Town Planner's Project Review
Wednesday, June 22, 2016

IX. 49 Main Street – Pauly's Pockets. Request for modification for lunette and discussion of other architectural details. The architectural renderings that were approved as part of the site plan for this mixed-use redevelopment included a detailed design for the lunette, the round granite element at the corner of the building above the first floor. The lunette that was installed does not match the approved design and the applicant is requesting approval of the design as built. The Architectural Design Committee has asked about several other details of the project that should be discussed. Paul Eja, proprietor of Pauly's Pockets, applicant; Michael Sievert, MJS Engineering, engineer. Tax Map 5, Lot 1-2. Central Business District.

Details of hood from working drawings:

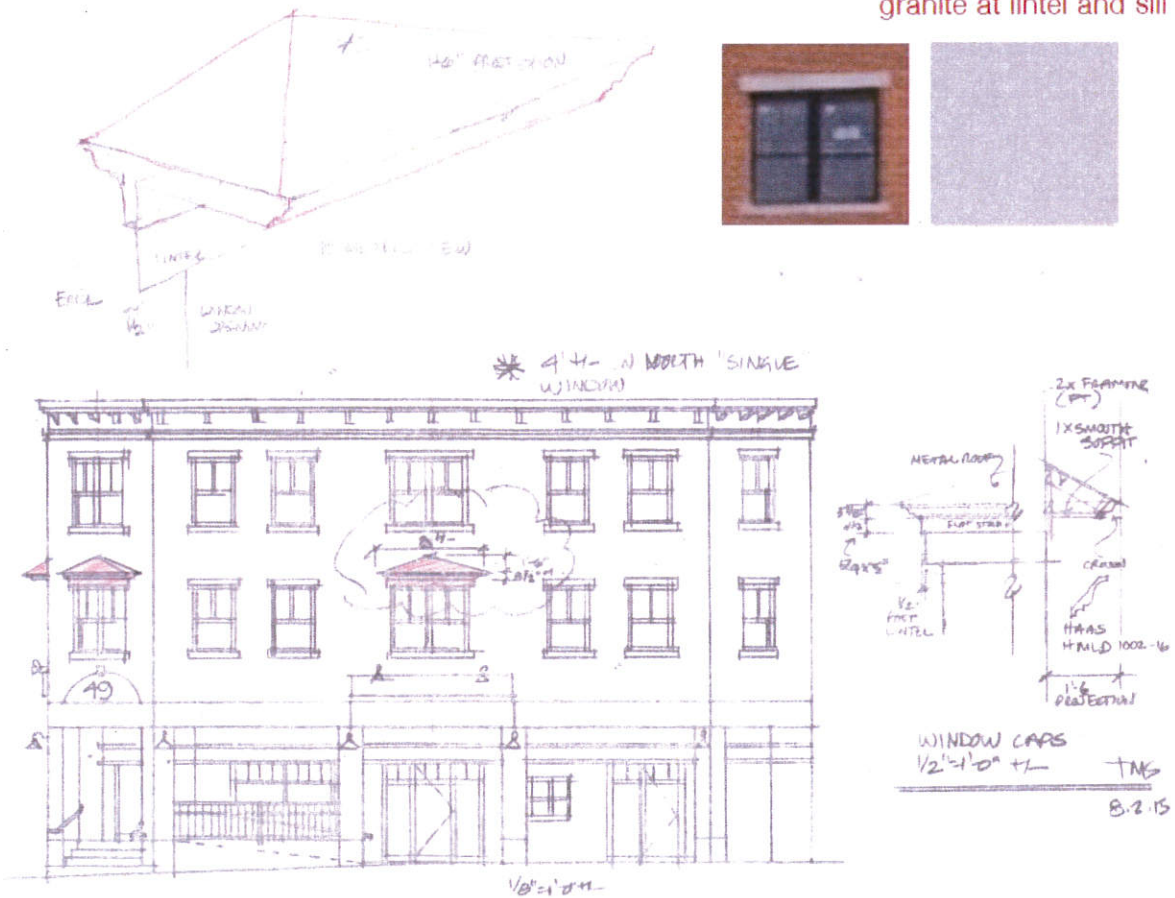
Window hoods. The three hoods were recently installed over the windows. The Design Committee expressed concern about whether the installed hoods were in fact constructed to design. Mike Sievert is examining this, including the height of the hoods.
